Residential Development at Anchorage  
28 North Parade, Falmouth, Cornwall, TR11 2TD

**Resubmission PreApp - Discussion Document, March 2021**

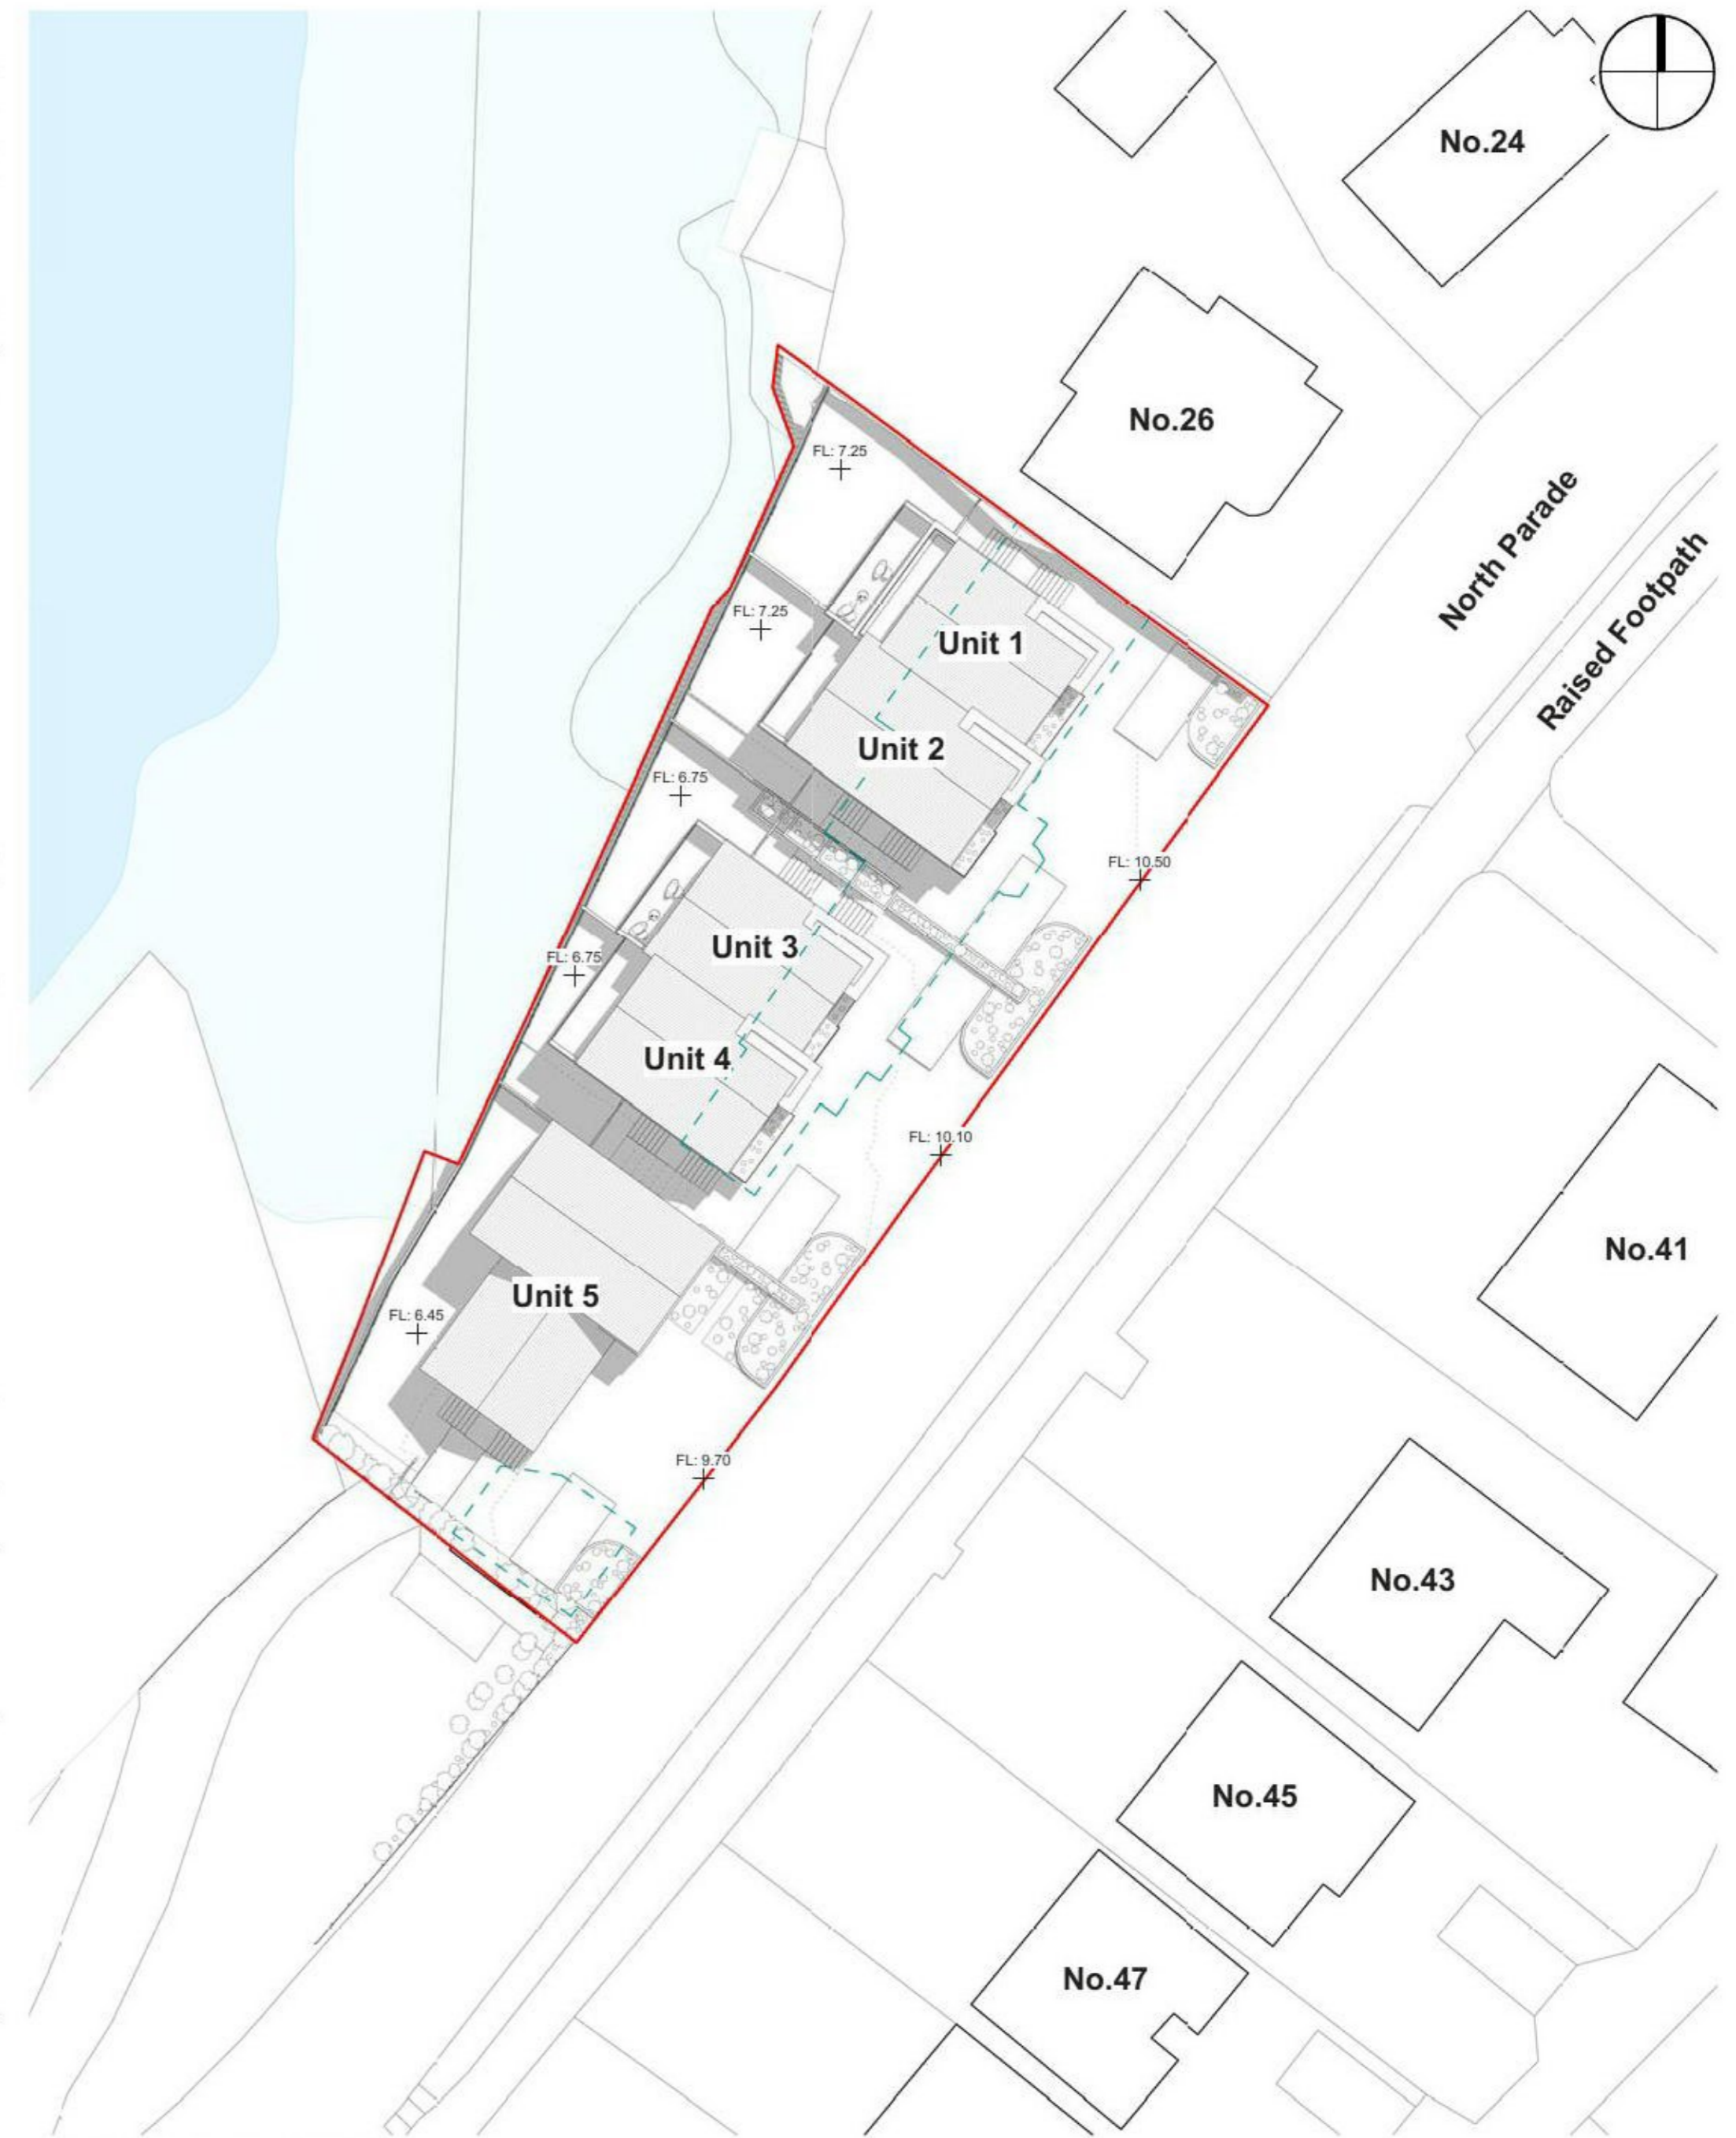
The scheme is reduced from 7 Units (4 semi detached dwellings and a block of 3 apartments) to 5 Units (4 semi detached dwellings and 1 detached dwelling). Resulting footprint comparisons and calculations of amenity area have been provided.

The proposed massing has been pushed away from the SW point, the approach to North Parade. The height, as seen from the road, steps from single storey, to 1.5 storey to 2 storey; a gradual increase in height. Illustrated on street scenes and 3D view comparisons.

The distance of unit 1 to the boundary and No 26 has been increased. The roof overhang and details of the top floor privacy flanking wall have been amended to reduce the impact on no 26. Side elevations and 3D 'view out' comparison from neighbour's dwelling are included.

The parking provision has been reduced to 1 space per dwelling. This allows forward exiting out of all spaces. Vehicle swept path have been prepared to demonstrate this.

Proposed Revised Site Plan (Ground Floor Layout)

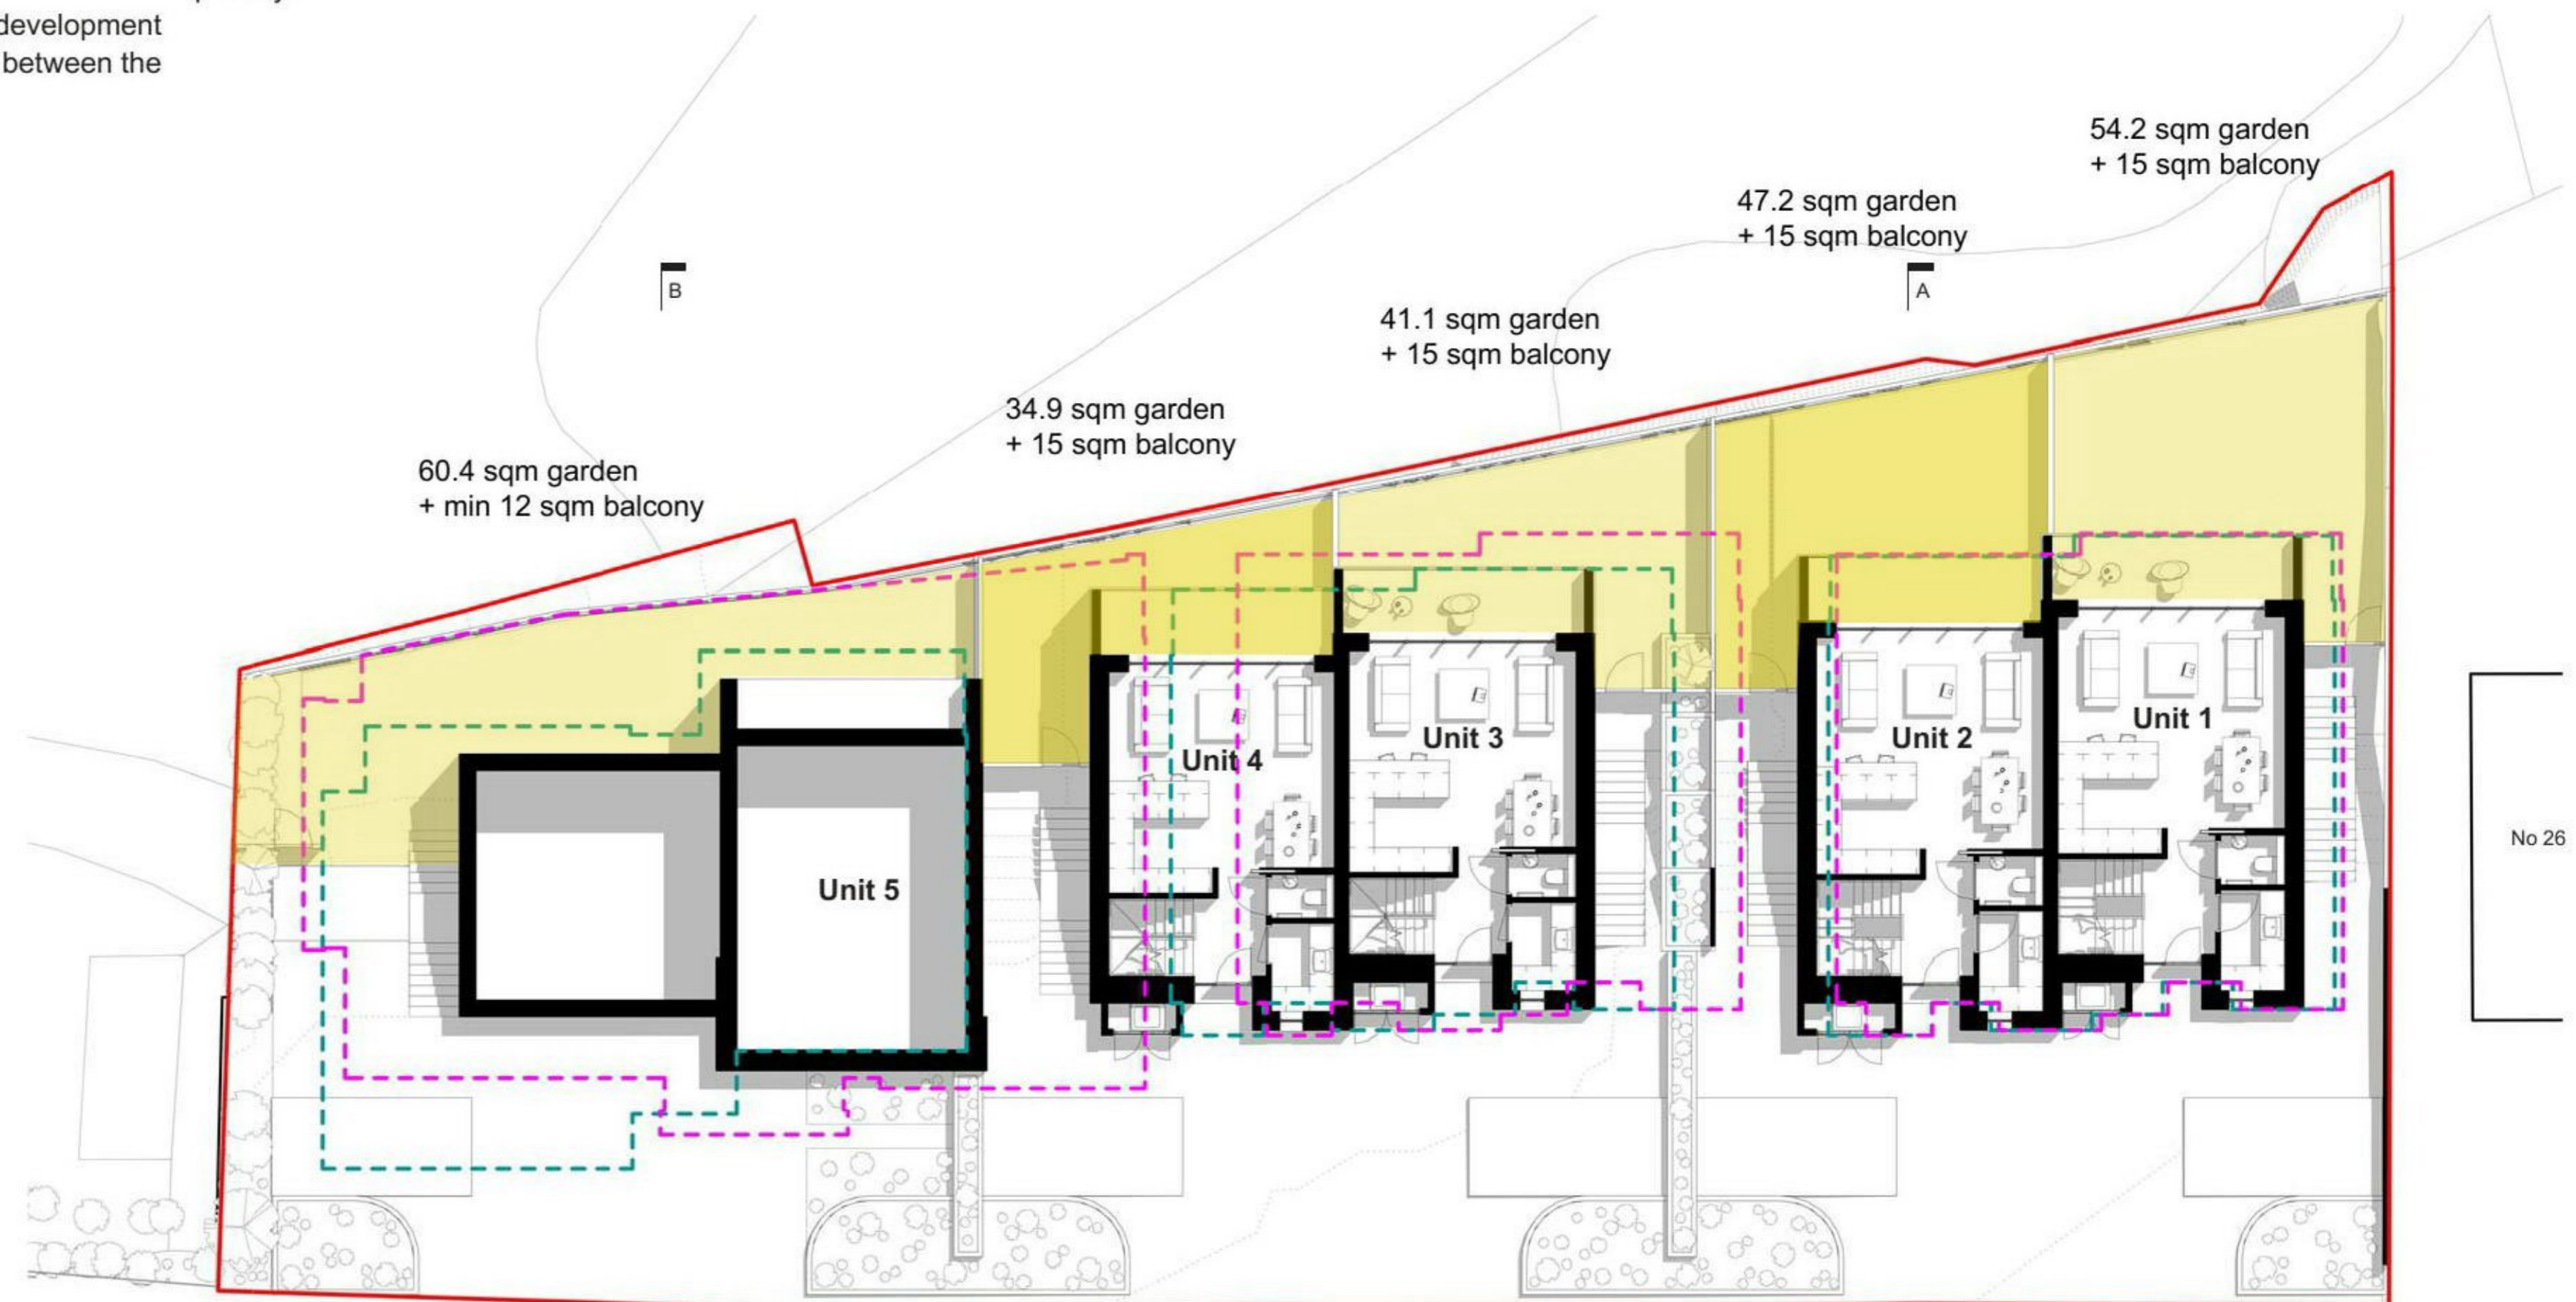
The purple dashed line shows the scheme that was submitted for PreApp consultation in July 2020. This scheme proposed 9 Units (4 semi detached houses and a block of 5 apartments)

The blue dashed line shows the scheme that was submitted and then withdrawn in January 2021. This scheme was for 7 Units (4 semi detached houses and a block of 3 apartments).

The floor plans indicate the proposed revised scheme of 5 units (4 semi detached dwellings and 1 detached dwelling).

The footprint shows a progressive reduction of development from the SW corner of the site, increased gaps between the dwellings and increased gap towards no 26.

On the proposed revised scheme allows for a min of 50 sqm of high quality usable outdoor amenity area for each units.

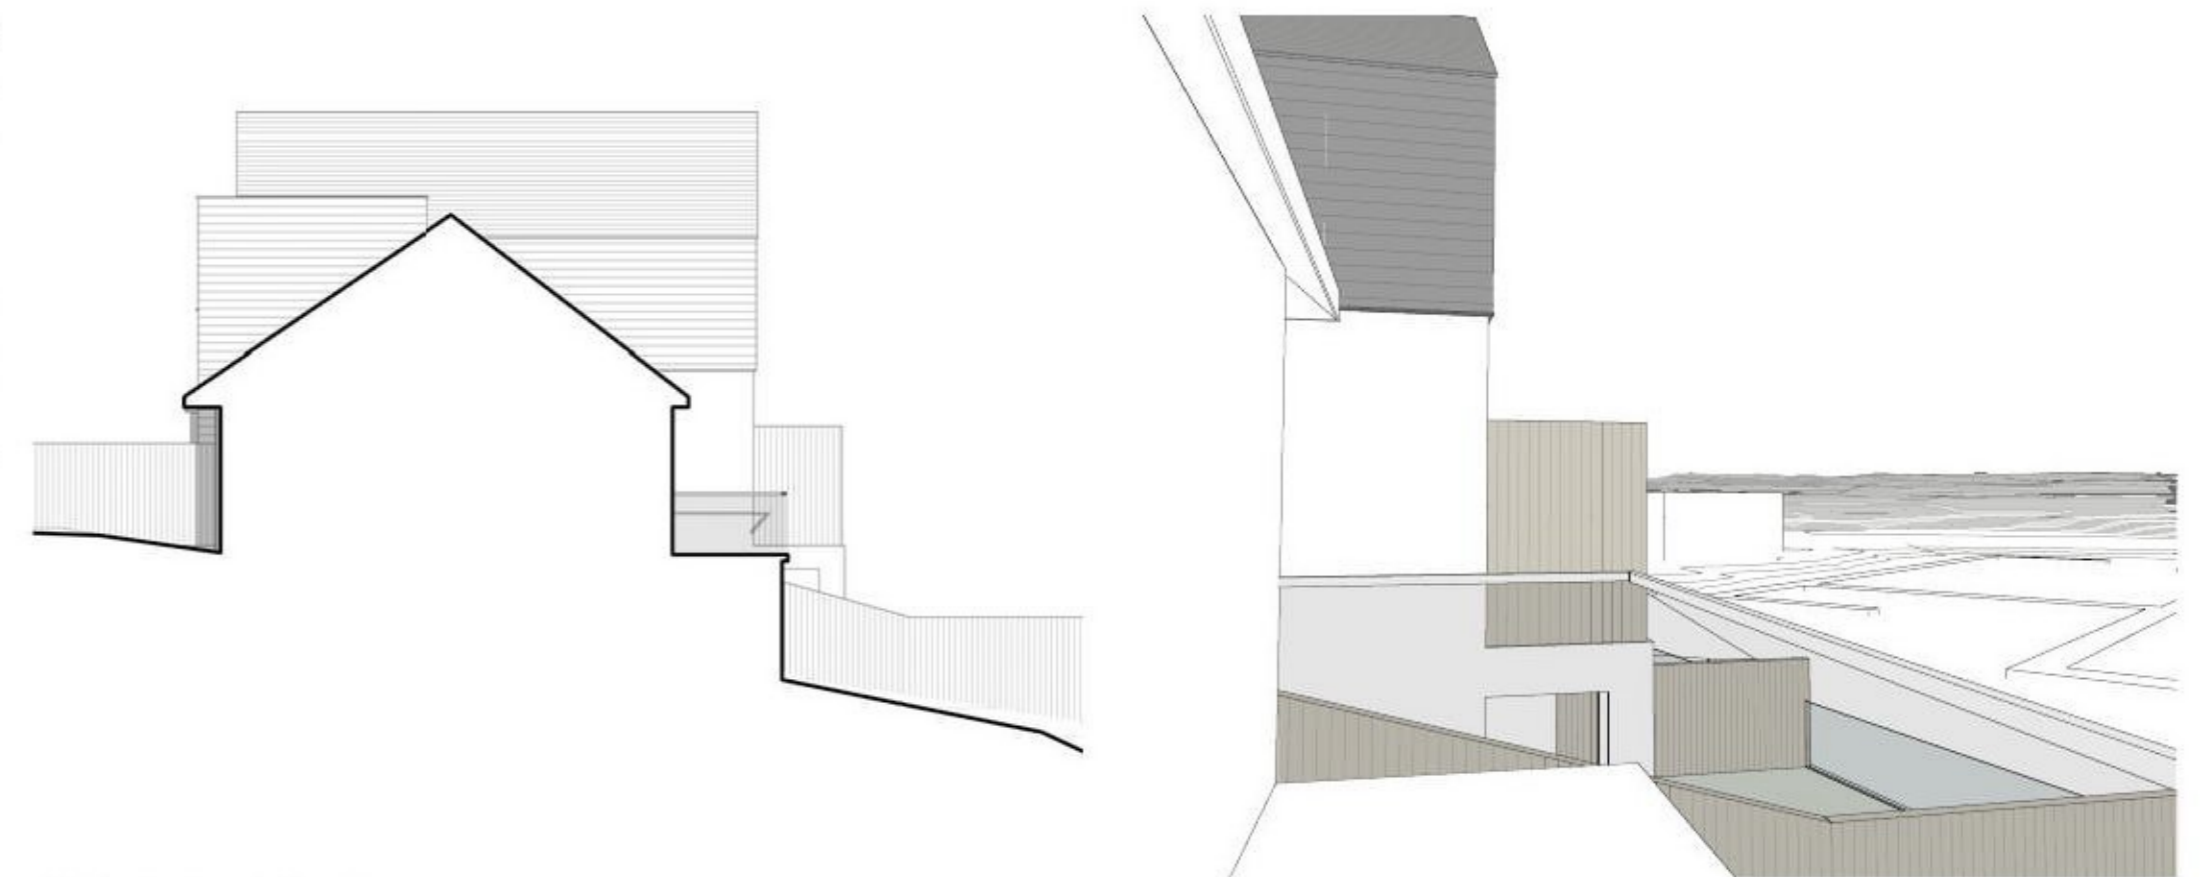
In response to concerns of impact of Unit 1 on the amenity of No 26 in terms of outlook and overbearing the scheme has been reviewed.

The proposed dwellings make use of the topography of the site and step to the rear as they step down the slope. These steps have been utilised for the creation of a balcony terrace. In fact a similar stepping can be observed at the rear elevation of No 26.

When comparing the floor plans at each level, it can be seen that the rear building line of Unit 1 is very similar to No 26.

It is recognised that the proposed dwellings are a storey taller, so particular attention has been paid to the transition from No 26 to the proposed units. It is therefore proposed to omit the roof overhang of the top floor balcony of Unit 1. This significantly improves the outlook from No 26 adjacent to the development.

In addition, as mentioned previously the gap between Unit 1 and No 26 has been increased further. It should also be noted that currently the existing footprint of The Anchorage is built up to the boundary with No 26.
